GRADING & DRAINAGE PLAN

LAKE FOREST ADDITION

TOWN OF ADDISON
DALLAS COUNTY, TEXAS

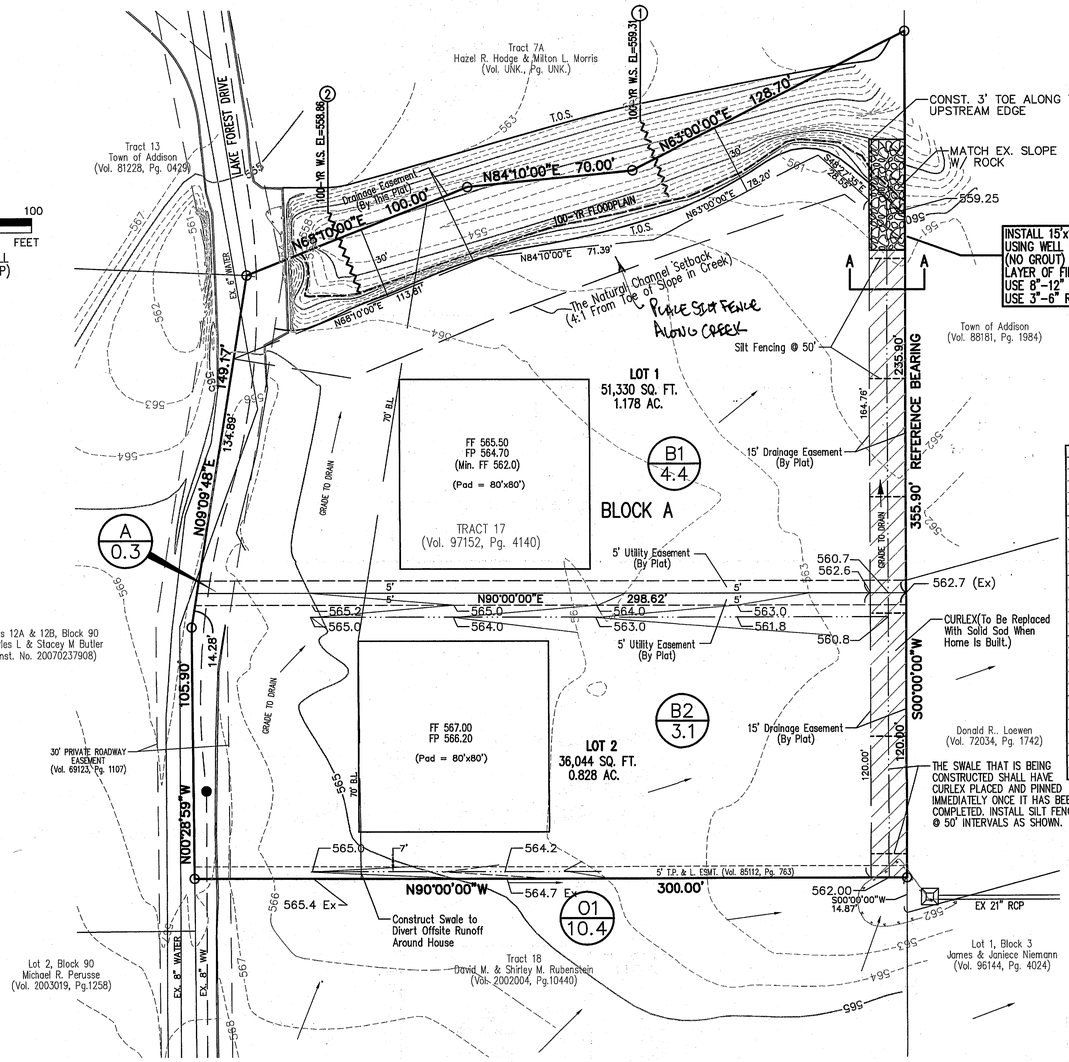
☐ PROVIDE A CONSTRUCTION ENTRANCE

☐ INDICATE SIZE AND LOCATION OF EXISTING AND PROPOSED UTILITIES.

SECTION A-A SWALE DETAIL
NTS

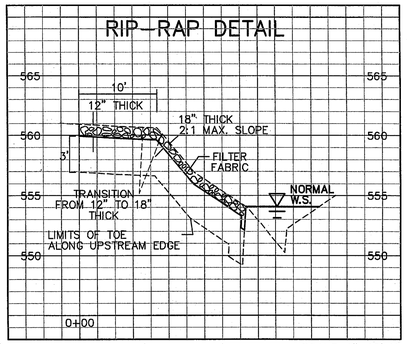
* CONTRACTOR SHALL STABILIZE FINAL SURFACE FOR FULL WIDTH OF EASEMENT (NOTE 12)

12. Contractor ~~Curlex stabilization~~ SURFACE STABILIZATION shall stabilize finished surface in swale with curlex (seed-impregnated) as shown. Solid sod shall be installed as each home is built.
